Access Compliance Report

Public Rights-of-Way

(Curb Ramps)

Intersection ID: 53775	Main Street: STRAWBERRY_FIELDS_LN	Cross Street: CHAPECLANE_RD	Location: SW
ADA ID: 9741F577A822	Ramp Type: BlendTrans1	Initial Pass/Fail: Fail	Overall Compliance: No
Severity Score: 10			
Codes/Mitigation Info/Possible Solution		Field Measurements/Component Compliance

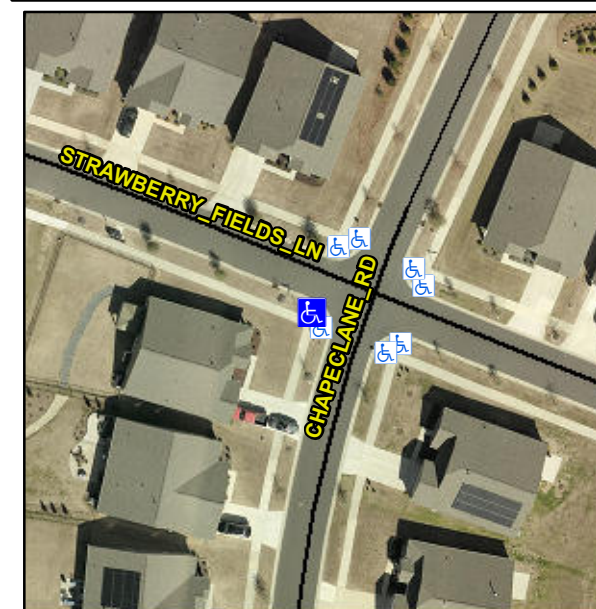
Remove & Replace Curb Ramp With Two New Directional Ramps or Equivalent.

R304.5.1, R304.5.3

Compliance	Description	Data	Compliance	Description	Data
N/A	Ramp Length (in)	96.0	Yes	BlendTrans Slope (%)	3.2
No	Ramp Width (in)	46.0	No	BlendTrans XSlope (%)	2.7
N/A	Flare Type LT	N/A	N/A	Flare Type RT	N/A
N/A	Flare Slope LT (%)	N/A	N/A	Flare Slope RT (%)	N/A
N/A	Flare Traversable LT?	N/A	N/A	Flare Traversable RT?	N/A
N/A	Landing Length (in)	N/A	N/A	DWS Provided?	N/A
N/A	Landing Width (in)	N/A	N/A	DWS Contrast?	N/A
N/A	Landing Slope (%)	N/A	N/A	DWS Length (in)	N/A
N/A	Landing X Slope (%)	N/A	N/A	DWS Full Width?	N/A
N/A	Landing Curb? (Y/N)	N/A	N/A	DWS Offset (in)	N/A
N/A	Shared Landing?	N/A			
N/A	Gutter Ponding?	N/A	N/A	Gutter Slope (%)	N/A
N/A	Gutter Lip Ht (in)	N/A	N/A	Gutter X Slope (%)	N/A
N/A	Painted X Walk1?	No	N/A	Painted X Walk2?	N/A
	X Walk 1 Direction	To NE		X Walk 2 Direction	N/A
	X Walk 1 Width (in)	N/A		X Walk 2 Width (in)	N/A
	X Walk 1 Slope (%)	1.9		X Walk 2 Slope (%)	N/A
	X Walk 1 X Slope (%)	2.1		X Walk 2 X Slope (%)	N/A
